**CITY OF DALLAS**  
**LANDMARK COMMISSION**  
Monday, November 7, 2016  
**AGENDA**

**1. 1321 COMMERCE ST**

Adolphus Historic District  
CA167-044(LC)  
Liz Casso

Request #1 - Proposed Elevation, Sections and Column Detail

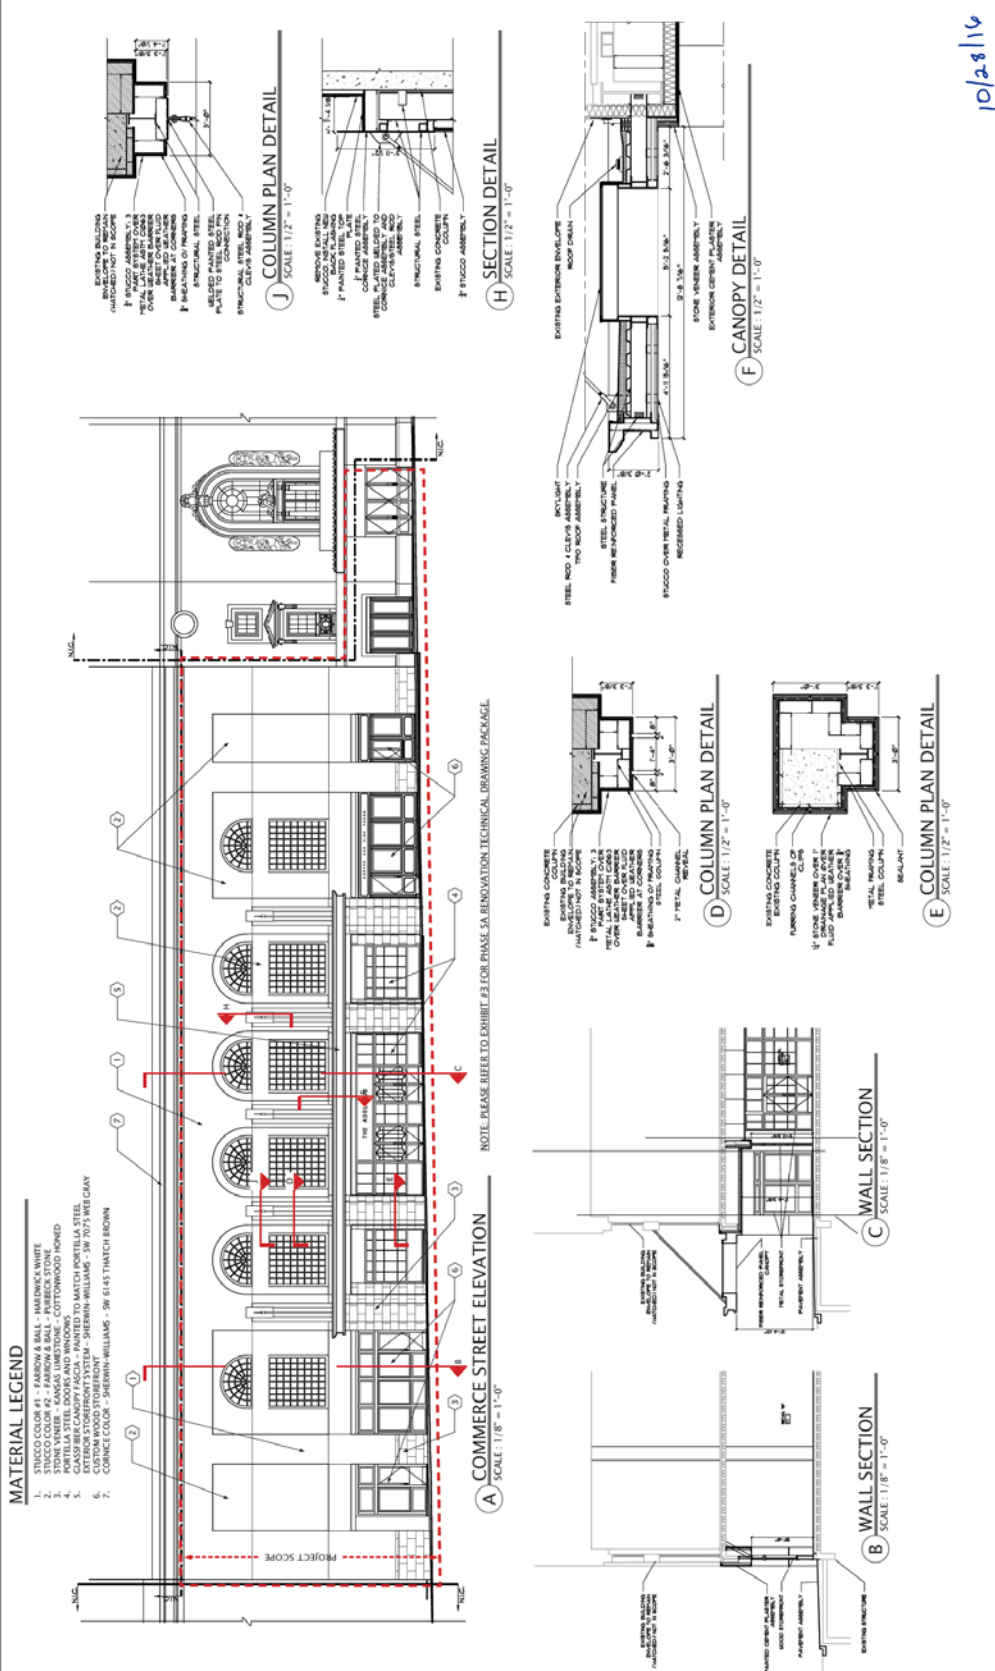
1. Construct new storefront and entry area on Commerce Street. Approved as submitted with conditions: Skylight be reduced in height so as not to be visible from Akard and Field intersections with Commerce. Reduce size of canopy anchor mounting plate. Suggest that canopy's be simplified: Retain the main center canopy; and Delete the two side canopies.
2. Install signage on Commerce Street facade. Approve.

The applicant has further simplified the design of the canopy by eliminating the columns supports from the original design, and the decorative metal valence-like feature. After the Task Force meeting, the applicant submitted revised drawings per the Task Force's comments. This included removing the canopy cover over the retail spaces that flank the proposed recessed lobby entry, reducing the size of the canopy anchors and reducing the height of the skylight canopy roof.

1. Construct new storefront and entry area on Commerce Street. Approve – Approve drawings dated 10/12/16 and 10/28/16 with the finding the proposed work is consistent with preservation criteria Section 3 for fenestration and openings, Section 5 for embellishments and detailing, Section 7 for Lighting and Landscaping, and meets the standards in City

Request #2 - Proposed Plaque Signs at Existing Hotel Entry

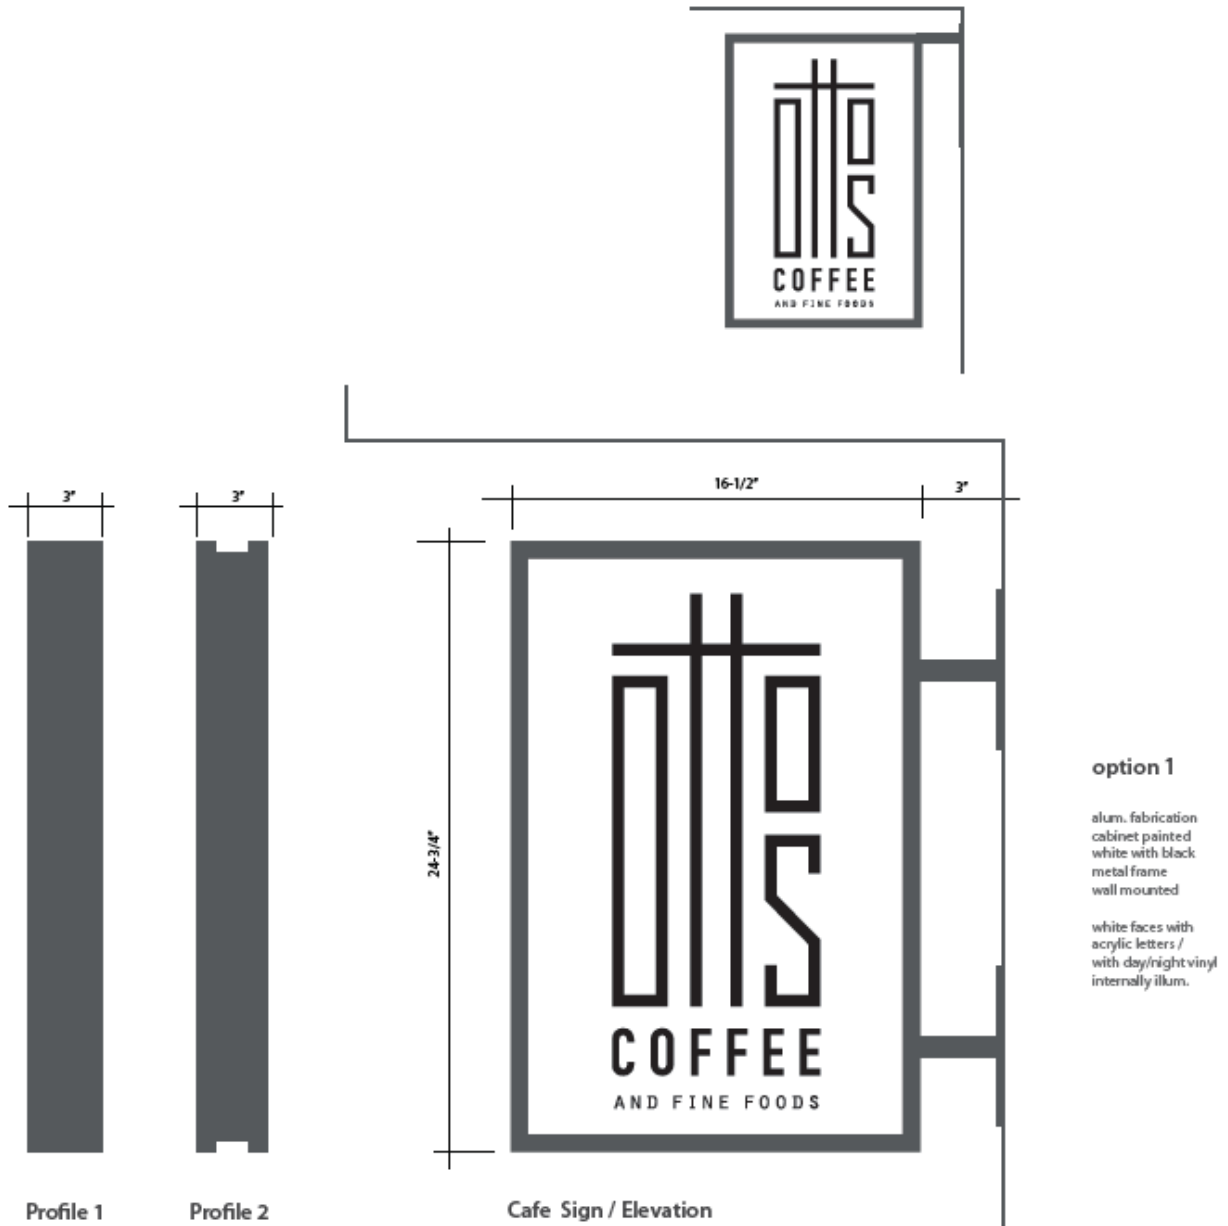
2. Install signage on Commerce Street facade. Approve – Approve drawings dated 10/12/16 and 10/28/16 with the finding the proposed work is consistent with preservation criteria Section 8 for signs, and meets the standards in City Code Section 51A-4.501(g)(6)(C)(i).

Proposed Signage and Plaza

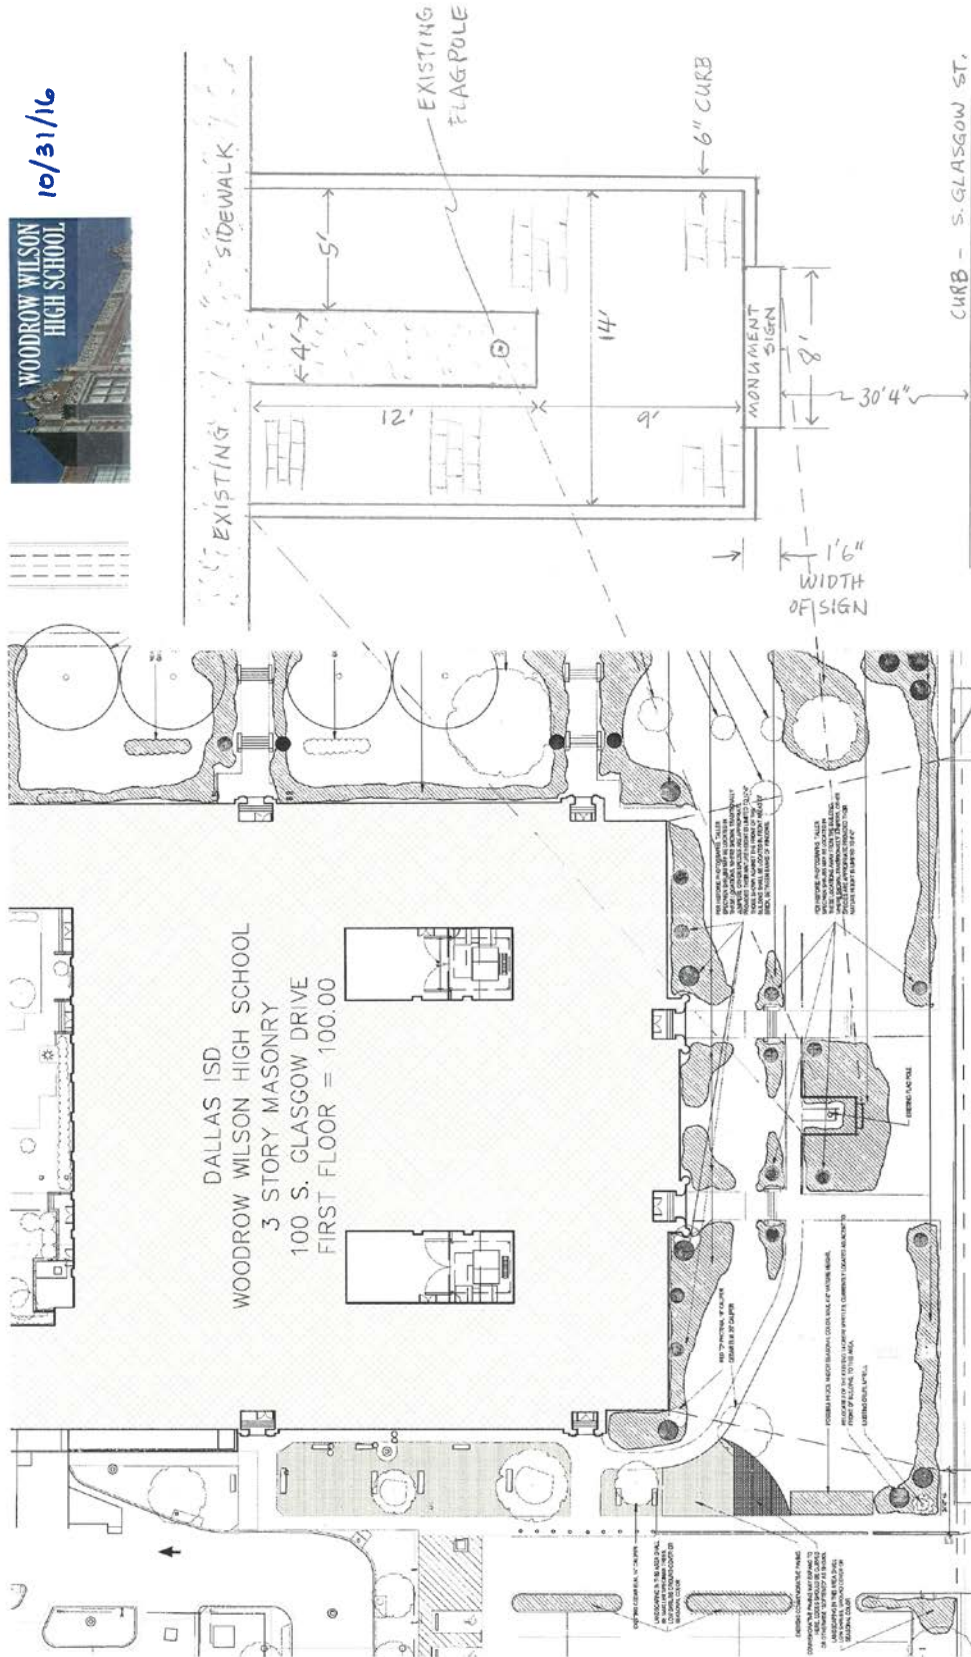
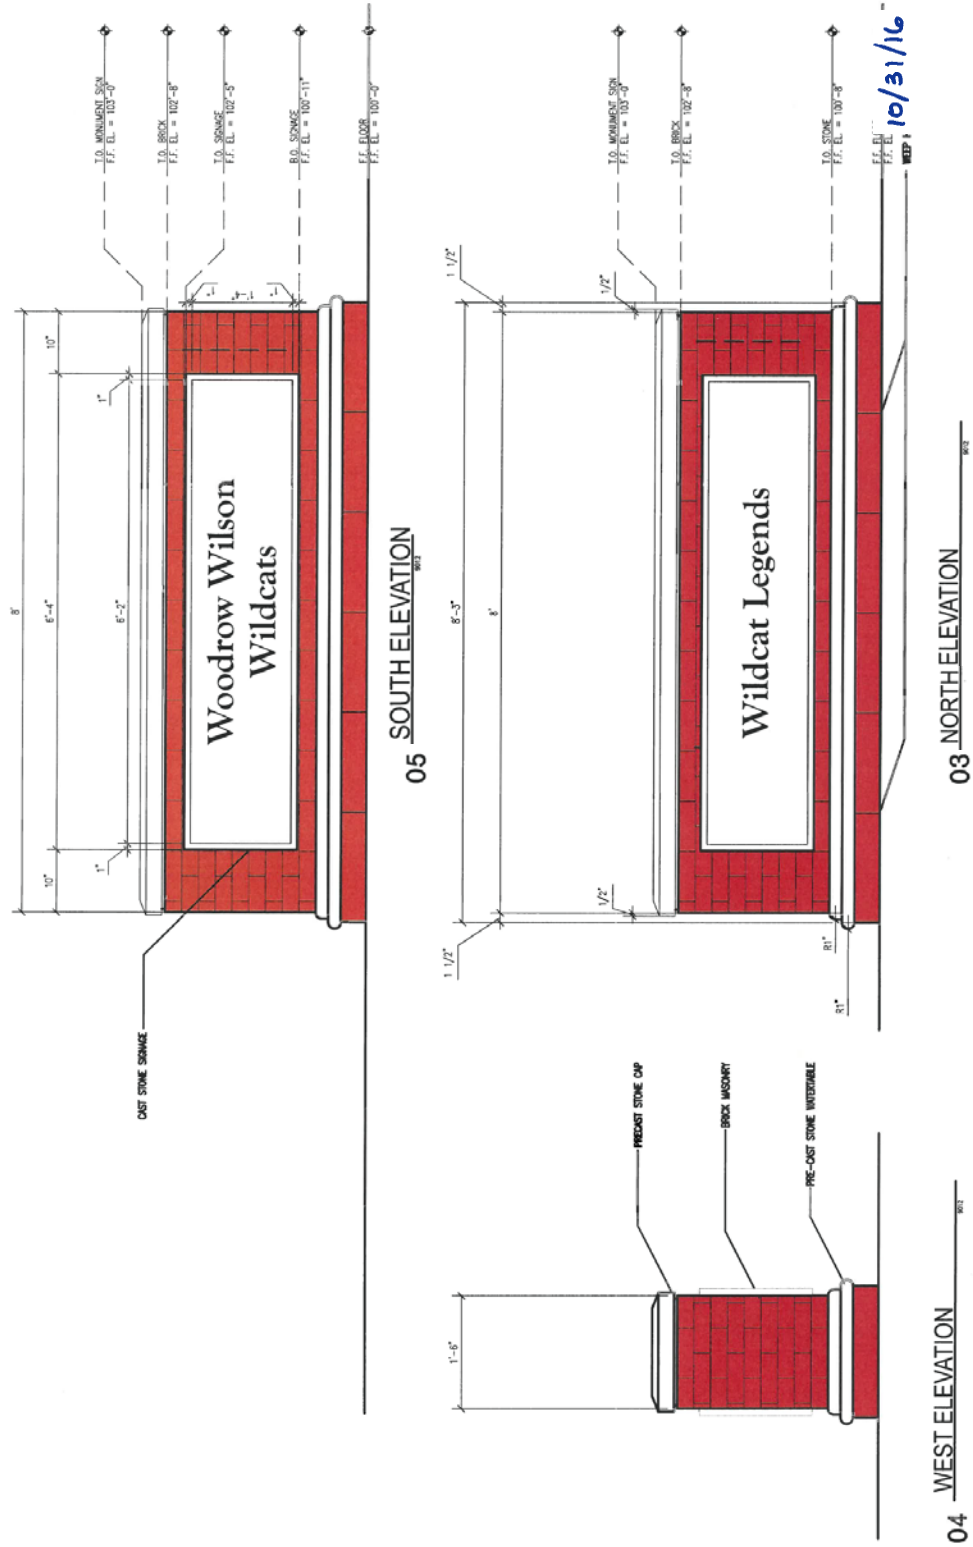
Install a monument sign and plaza. Approved with the following conditions: 1. Clarify font style and incorporate in drawings; 2. Submit details and dimension of plaza (may be done on site plan);

3. Update existing elevation drawings to include sign on back/north side of monument sign and correct label on north elevation drawing; 4. Consider including landscaping around sign and plaza with a soft edge in accordance with landscape master plan; 5. Study the slope of the lawn to determine if it will affect sign and plaza construction and height; 6. Consider concrete pavers as an option for plaza paving material; and 7. Continue to coordinate improvement projects with the landscape master plan.

Request 4: Site plan showing proposed light locations.

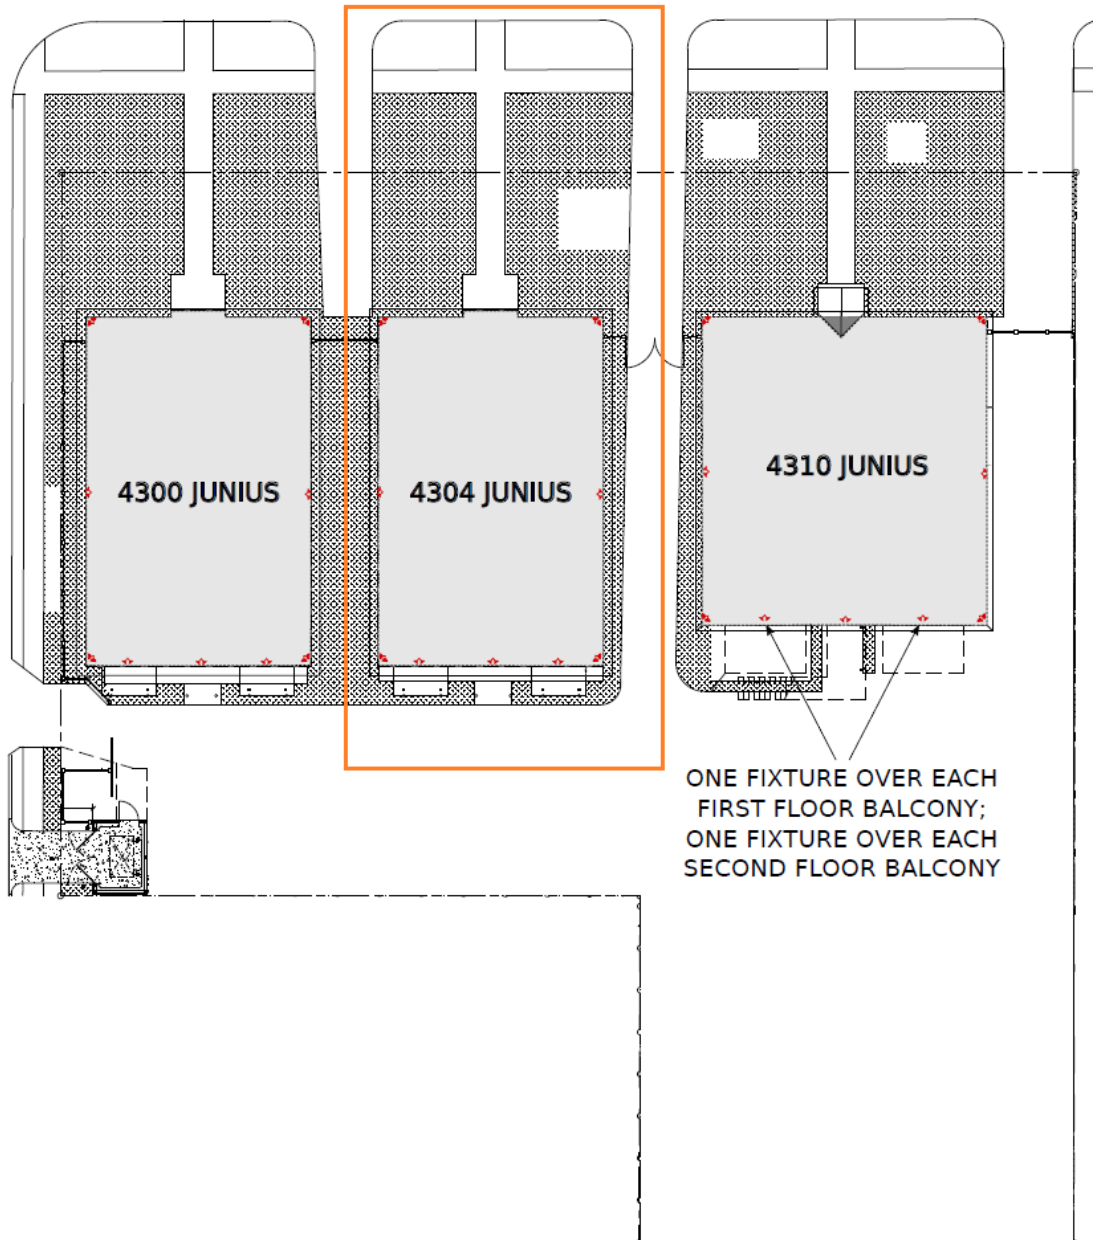
4. Install nine light fixtures on exterior of main structure. Approve with conditions – Approve site plan dated 10-6-16 with the condition that the proposed light fixtures are installed in the mortar. The proposed work is consistent with preservation criteria Section 2.5 and meets the standard in City Code Section 51A-4.501(g)(6)(C)(i).

3. Replace door on rear of main structure. Approve.
4. Install nine light fixtures on exterior of main structure. Approve with condition that the light does not impede on nearby properties and that the fixtures are mounted in mortar joints.

Request 4: Site plan showing proposed light locations.

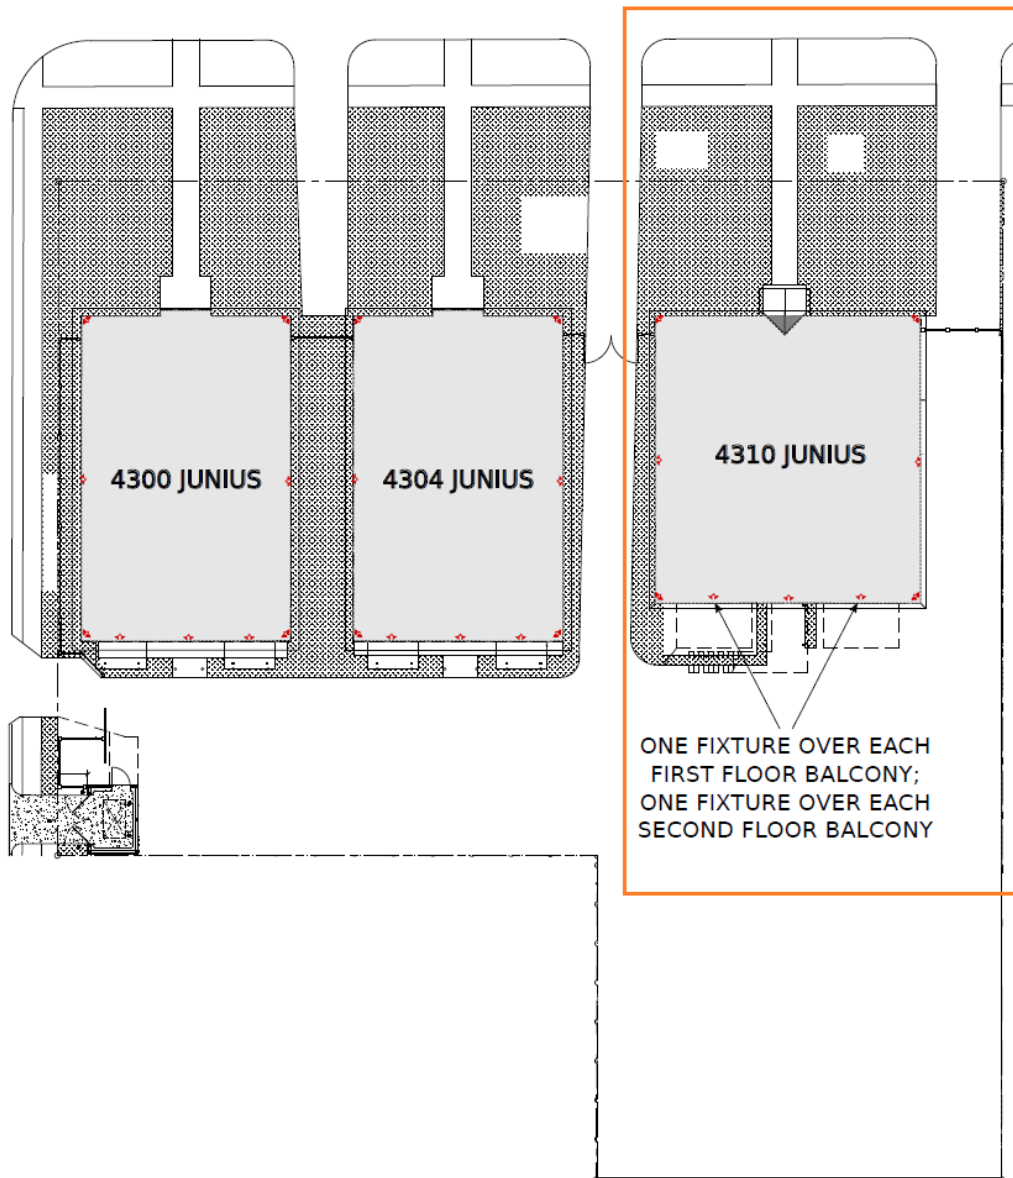
4. Install eleven light fixtures on exterior of main structure. Approve with conditions – Approve site plan dated 10-6-16 with the condition that the proposed light fixtures are installed in the mortar. The proposed work is consistent with preservation criteria Section 2.5 and meets the standard in City Code Section 51A-4.501(g)(6)(C)(i).

- style and period.
2. Replace four sets of patio doors on rear of main structure with wood patio doors and paint. Brand: Benjamin Moore. Color: PM-3 "Decorator's White". Approve with condition that the mullions are expressed on the outside of the door.
  3. Replace pedestrian door on rear of main structure. Approve.
  4. Install eleven light fixtures on exterior of main structure. Approve with condition that the light does not impede on nearby properties and that the fixtures are mounted in mortar joints.
